WOLF CREEK

WM 92-0035

Subject: Docket No. 50-482: Inservice Inspection Program
Relief Requests

ISI RELIEF REQUEST IIR-23

FIGURE 1

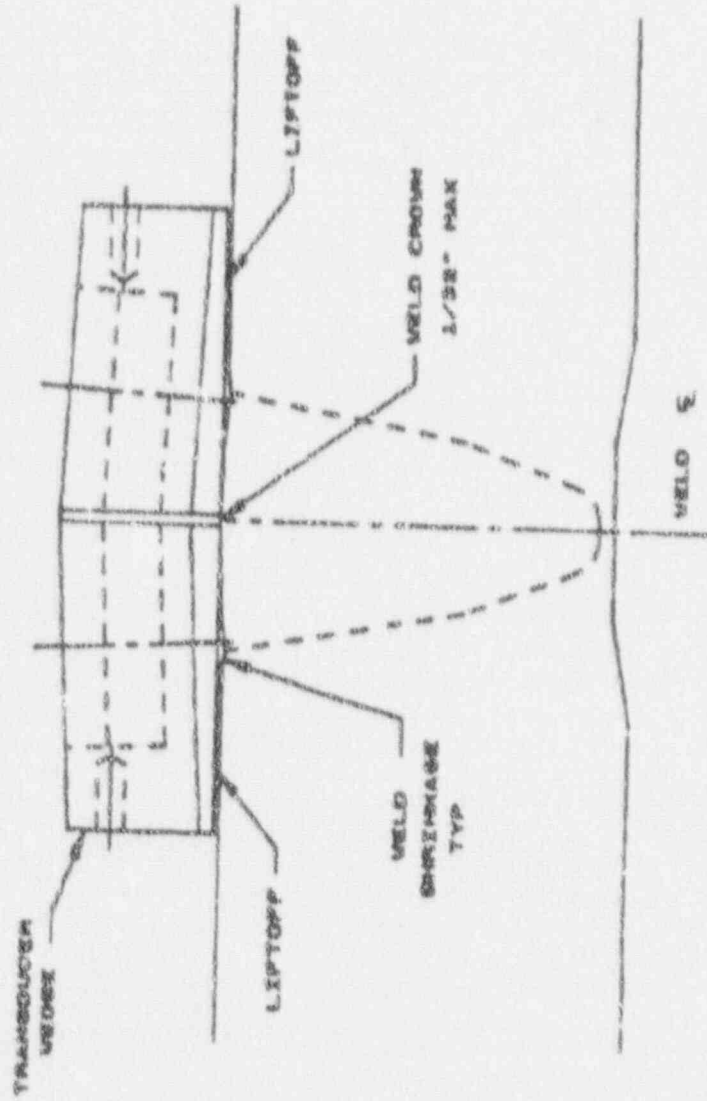
Basis for Relief: The transducers used to examine Cast Stainless Steel (CSS) were too large to maintain sufficient contact in the circumferential scanning mode (reference Figure 1). They did, however, maintain adequate contact when scanning perpendicular to the weld axis.

With welds F207, F307, F407, F305, F405 and F306, the weld crown and weld shrinkage causes transducer lift off. With welds F203 and F303, the weld taper causes transducer lift off.

Basis for Relief: The transducers used to examine Cast Stainless Steel (CSS) material were too large to maintain sufficient contact when running along the weld crown (circumferential examination). Thus, resulting with 0% inspection using the circumferential scan (reference Figure 1).

Alternate Examination: The code required volumetric examination will be completed perpendicular to the weld axis from two (2) directions.

Alternate Examination: The code required volumetric examination will be completed perpendicular to the weld axis from two (2) directions.

Figure 2

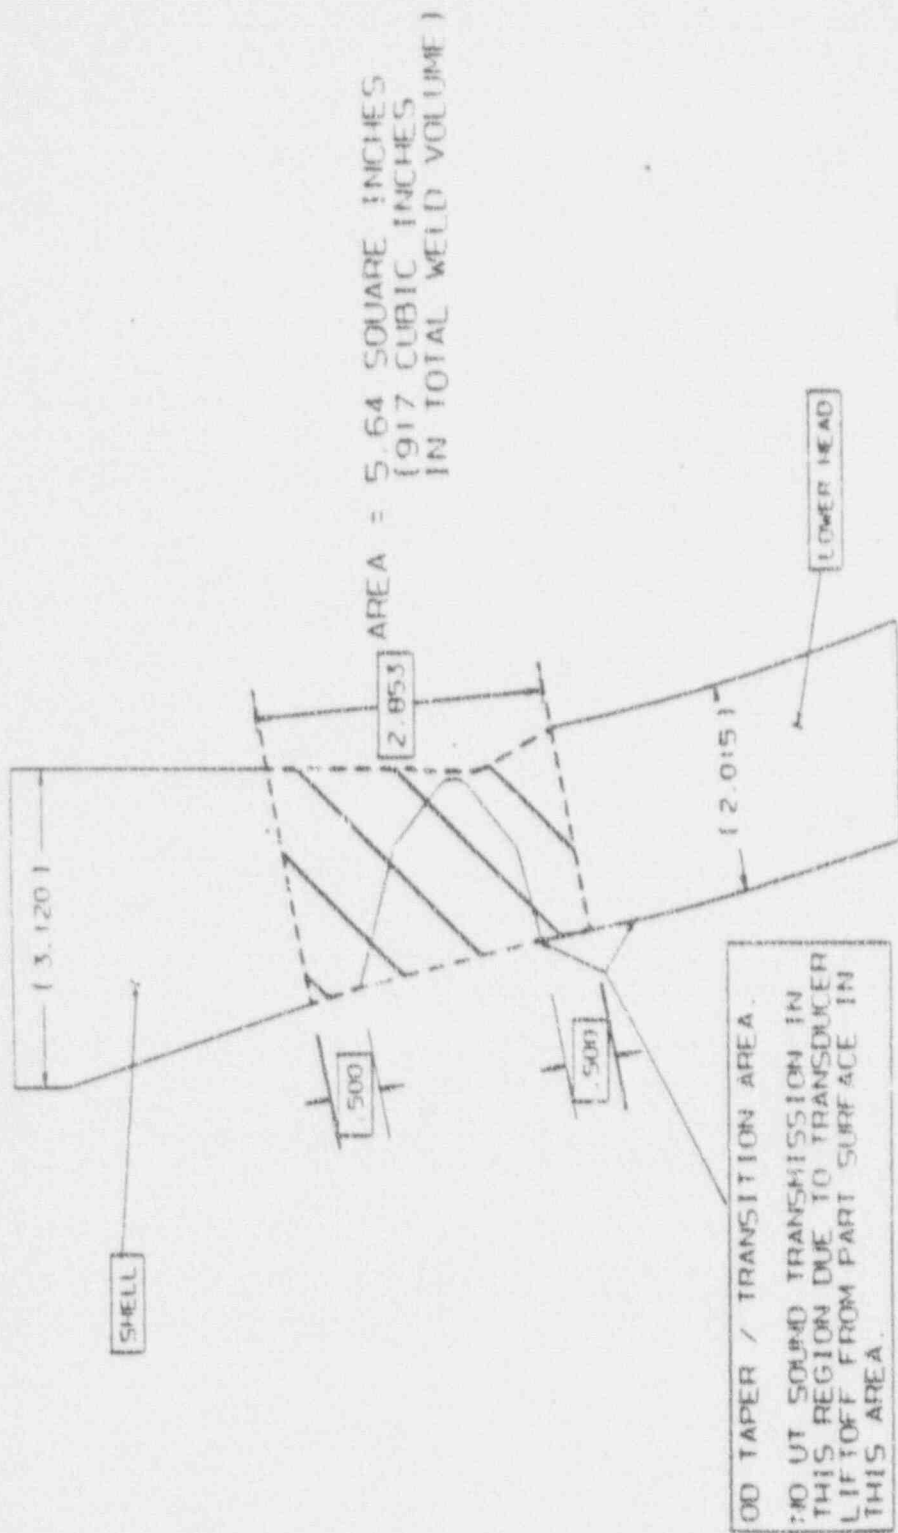
Basis for Relief: The surface examination of the subject integrally welded attachments (lugs) are 24% obstructed on two (2) of the lugs. The obstruction is a result of a permanent hanger that is used to support the Residual Heat Removal (RHR) piping. The diagonal supports of this hanger cross over the required inspection area on two of the lugs (reference Figure 2).

Alternate Examination: None; the Code required surface examination will be completed to the maximum extent practical.

Figure 3A

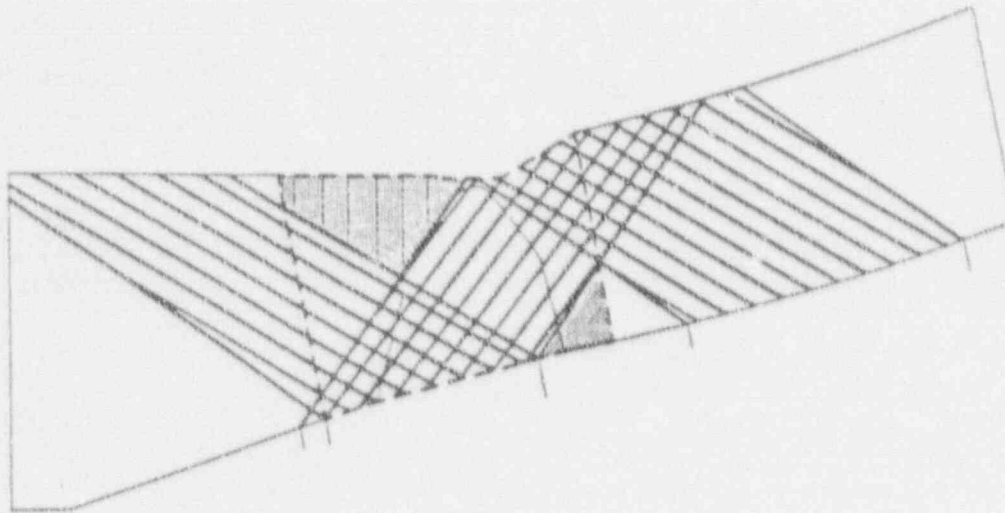
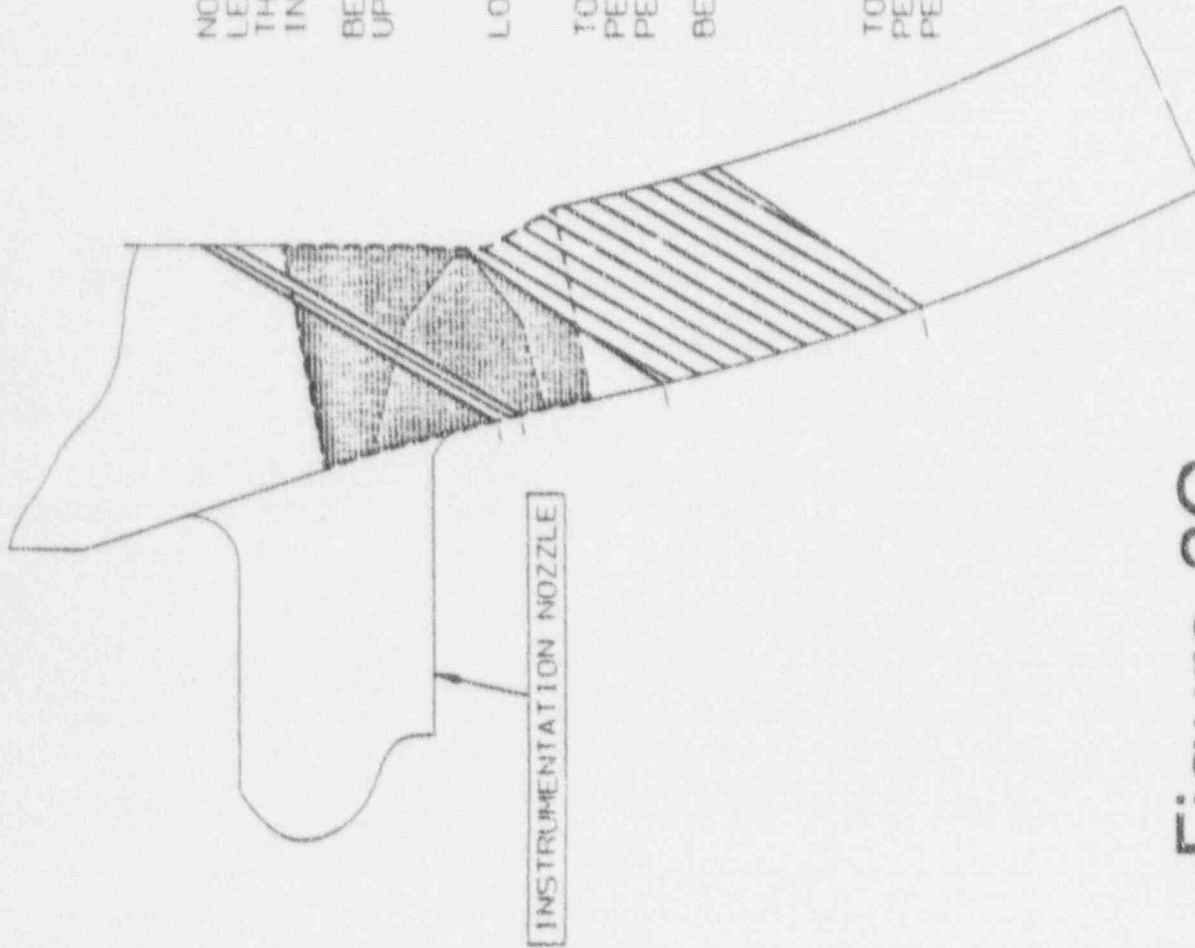
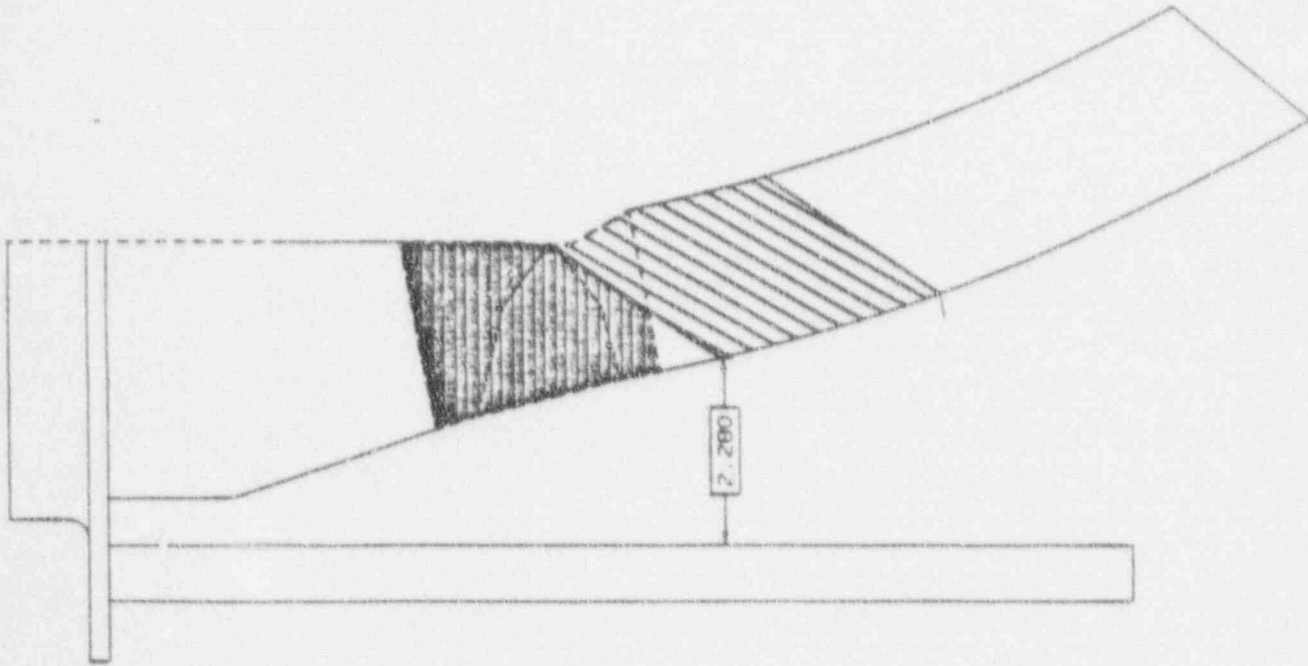
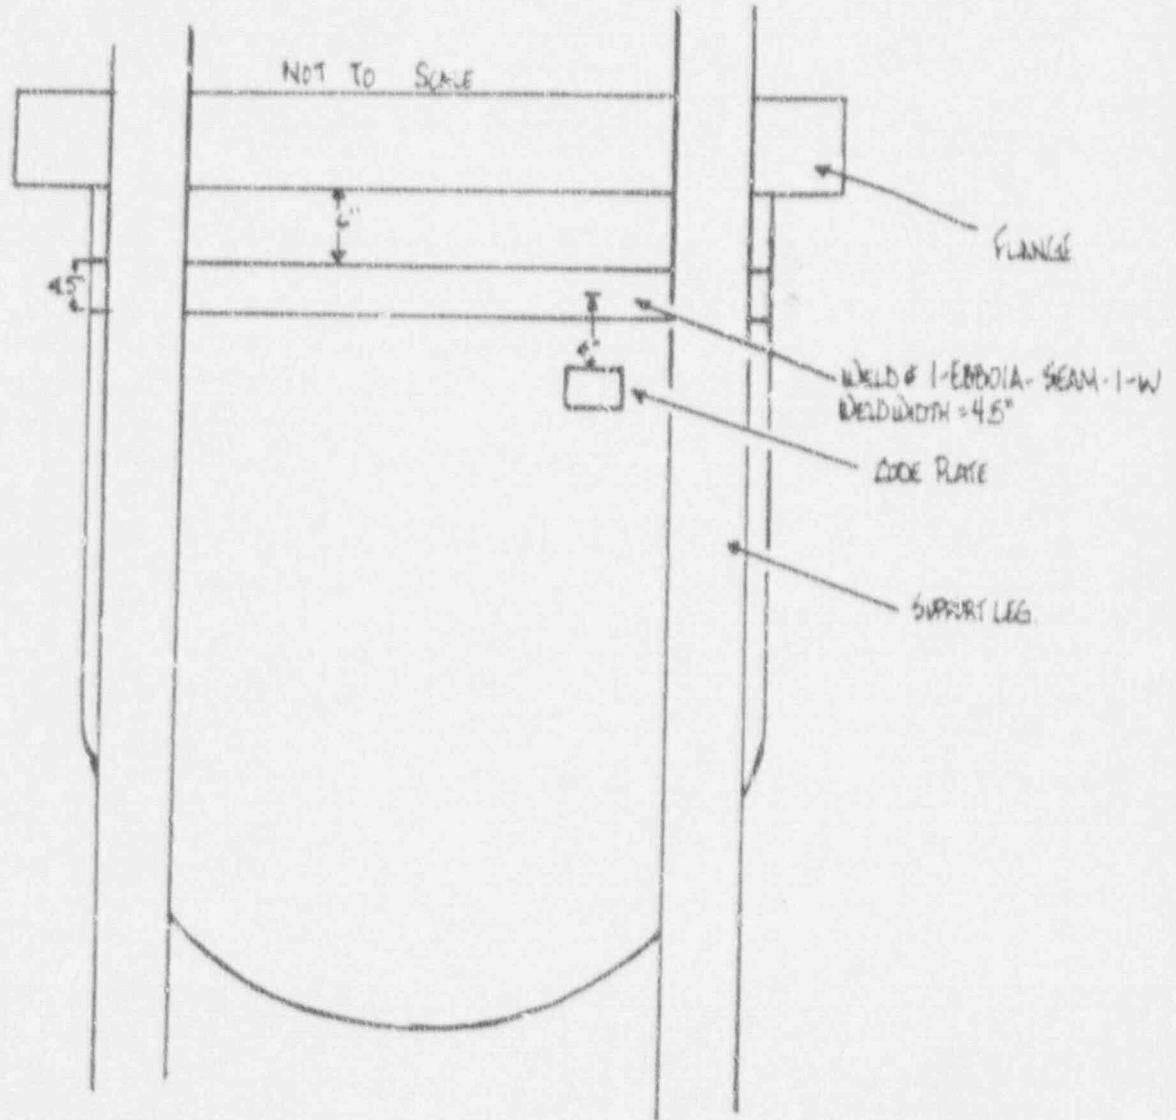
The circumferential examination was 100% limited due to the weld configuration (reference Figures 3A through 3D for the percentage breakdown).

The transducers used to examine Cast Stainless Steel (CSS) material were too large to maintain sufficient contact when running along the weld crown. However, Wolf Creek contends that other transducers may have maintained better contact along the weld crown, but would not have provided as an effective examination. This is because the transducers used to examine this CSS material were designed specifically to enhance the flaw detection capabilities.

Alternate Examination: None; the Code required volumetric examination will be completed to the maximum extent possible.

Figure 4

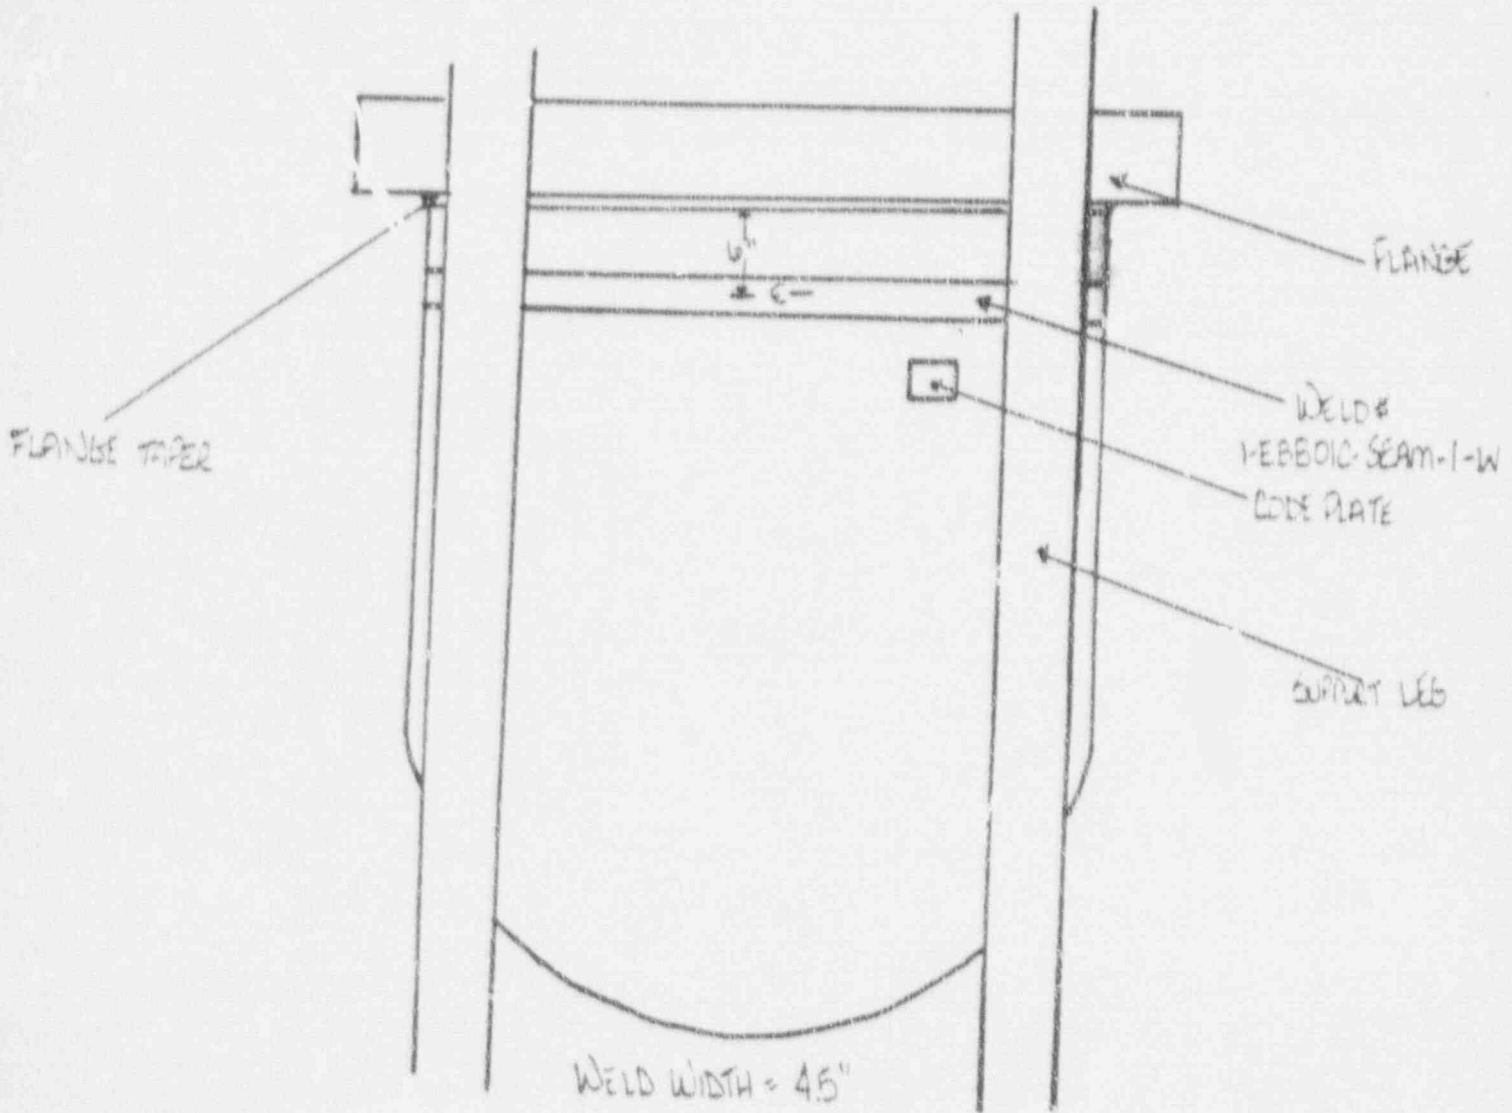
Basis for Relief: The volumetric examination of the subject weld is 22.4% obstructed by four (4) supports. The 60° axial scan on the tubesheet side is 20% obstructed by the support flange. The obstruction results from insufficient base metal between the weld and flange to complete this angle beam examination. There is approximately 1% obstruction due to weld taper and the code data plate. Reference Figure 4 for weld layout.

Alternate Examination: None; the Code required volumetric examination will be completed to the maximum extent practical.
